One Pukeahu Park

Assessment of the March 2023 proposal

BUILDING ENVIRONMENTAL PERFORMANCE SIMULATION

April 5, 2023

FIGURE 1 WEST ELEVATION OF THE PROPOSED DESIGN SHOWING SCALE OF CONSENTED BUILDING AS BRICK RED AND OF PROPOSED BUILDING AS BLUE (FROM AEE-APPENDIX-3---CONSENT-SCOPE-DIAGRAMS,PDF)

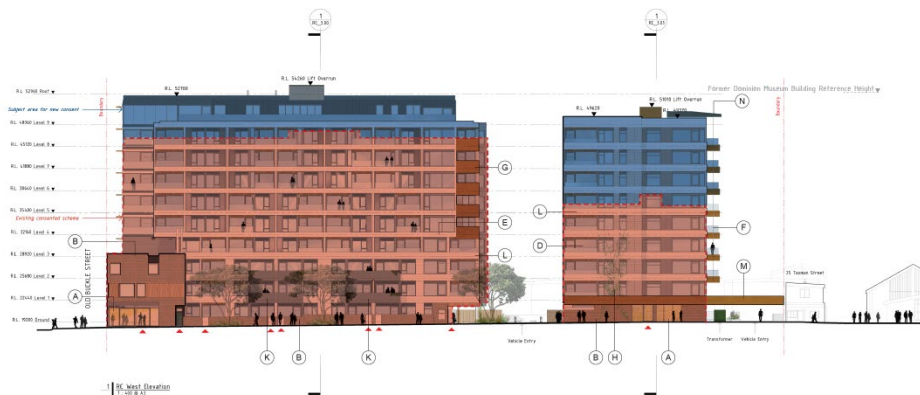
In reality, this assessment of the building that is now proposed cannot be compared to the aerodynamics of the “Consented Design” as that design was approved with an expectation that:

- 1) The consented buildings had adjusted the bulk of the design to be significantly shorter than in the original wind tunnel test which had identified the neighbourhood worsening of the wind;
- 2) The consent had been awarded *conditional on further design work to improve the proposed off-site amelioration measures*;
- 3) The provisionally consented off-site amelioration measures were in response to the lower bulk of the consented buildings, not to the original wind tunnel test.

FIGURE 3 OFF-SITE WIND MITIGATION OPTIONS CONTAINED IN WSP REPORT: WIND_ADDITIONALTESTING(WSP).PDF

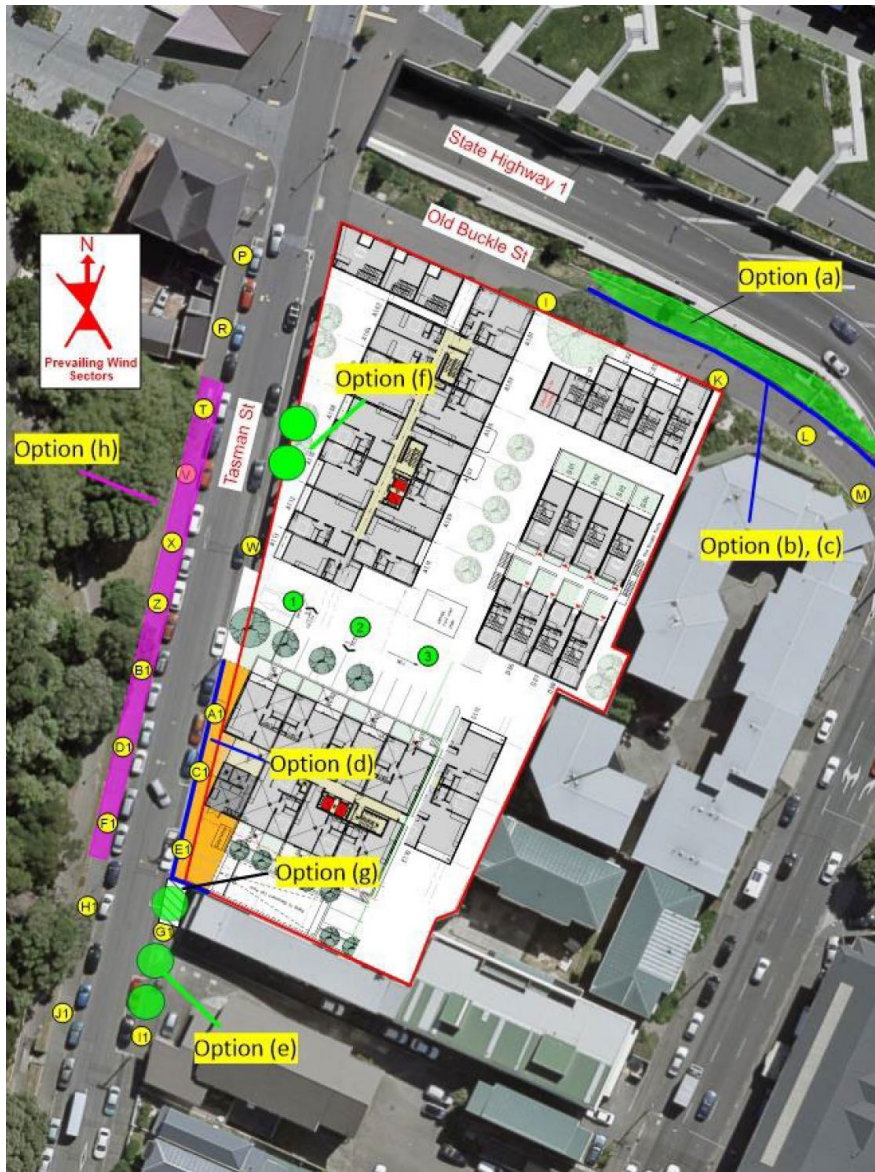
The questions that remain to be considered in light of this latest application are much the same as those posed in the last advice provided to WCC in September 2022. Off-site wind mitigation measures were proposed for the positions listed as options a through h in Figure 3:

Options d, e, g and h (see Figure 3) – amelioration around the Southern building

The proposed canopy (Figure 2) on the Southern building, as documented in the September review of the design proposal, has a small benefit in terms of safety under the canopy and near the building. I would note that However, as noted then: “*The other wind tunnel tests show the canopy would be far more effective here if, in addition to extending horizontally, it could be combined with vertical porous screens and trees.*” I cannot see evidence of these trees in the design now proposed, even though for a building of the scale now proposed, the earlier wind tunnel tests showed they were essential. In this context, the other issue that was highlighted in the September advice was that the models of trees used had to guard against horizontal flows – that is they needed to be the equivalent of a dense and tall (95m) hedge, not a canopy tree. Of interest again, it is the Northerlies whipping around the Southwest corner of the building that are the major issue from the Wind Tunnel Test results.

FIGURE 4 WIND TUNNEL TEST 'TREES'

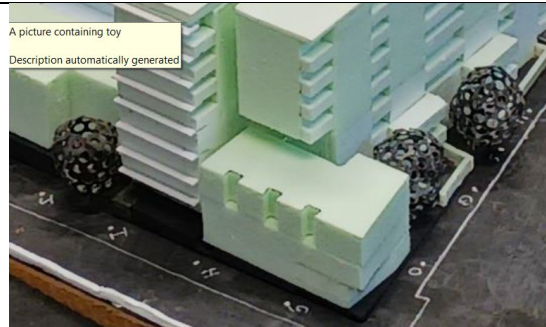
It must also be remembered that the wind shelter “devices” tested in the wind tunnel are of the shape shown in Figure 4, not the shape wind hardy trees adopt in reality (Figure 5) in urban areas. As noted in the September 2022 advice, trees of the shape shown in Figure 5 would need significant underplanting to provide pedestrian level shelter.

Buckle Street / Tasman Street intersection – wind tunnel test on left – existing situation on right

FIGURE 8 POINT 1 IN THE ORIGINAL WIND TUNNEL TEST

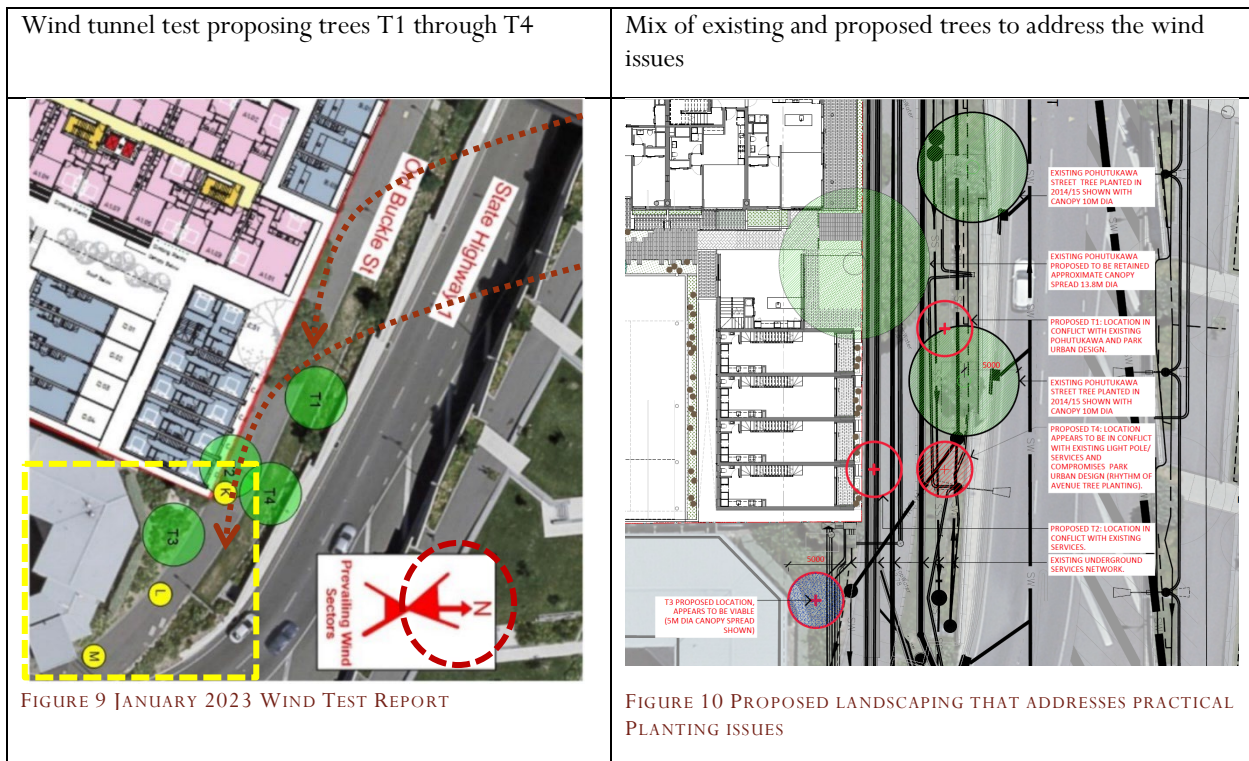
- The canopy on the South building is beneficial;
- Some form of wind screen needs to be associated with the canopy to effect the best result close to the building;
- The consented shorter building causes far less of a problem on the opposite side of Tasman Street from the development than does the now proposed building;
- It is worth noting that the on-site wind speed reported in the original wind tunnel test – point 1 in that report (Figure 8) - which is outside the purview of the city, because it is within the development and thus not on public land, would likely be far improved with the shorter consented building.

FIGURE 13 PLAN OF WIND TUNNEL TREES MADE TRANSPARENT TO OVERLAY ON WRAIGHT ASSOCIATES' PLANTING PLAN

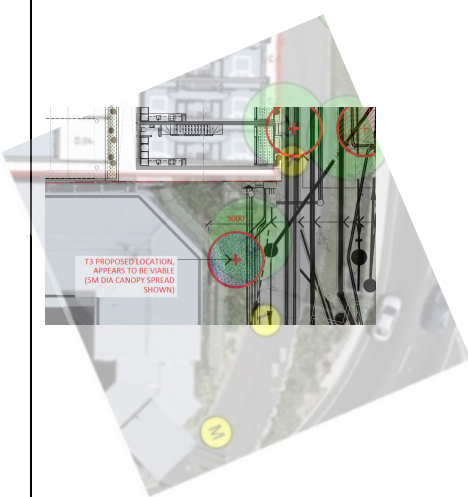
Note: green shaded trees from wind tunnel test report are shown as much bigger than Wraight Associates report (8 - Wind_Wraights-WSP-WakaKotahi.pdf) has drawn from Wind Tunnel Test

Illustration from WSP wind tunnel test *ae-appendix-12a--wind-mitigation-study-consented-scheme.pdf* of the scale models of trees – these appear to be closer to 5m in radius, not 5m in diameter? Note also the shape

Figure 13 and Figure 14 are provided to explore the practicality of the off-site measures proposed for the footpath at the Northeast corner of the site. Reading the data in Figure 11 and Figure 12, the following issues should be noted:

- 1) The initial wind tunnel test demonstrated that the wind in Southerlies will be made much worse than they are currently, but the amelioration studies focused only on the effect of off-site wind shelter during Northerlies, where backwash off the proposed buildings is the issue.
- 2) Examining the summary right hand column in each figure, it is clear that at each measurement point the annual gust speed is higher for the now-proposed, taller development. While the numbers individually are within the reading error within the WSP wind tunnel, the fact that all three are higher for the taller building is evidence of the worsening of the wind due to the extra height.
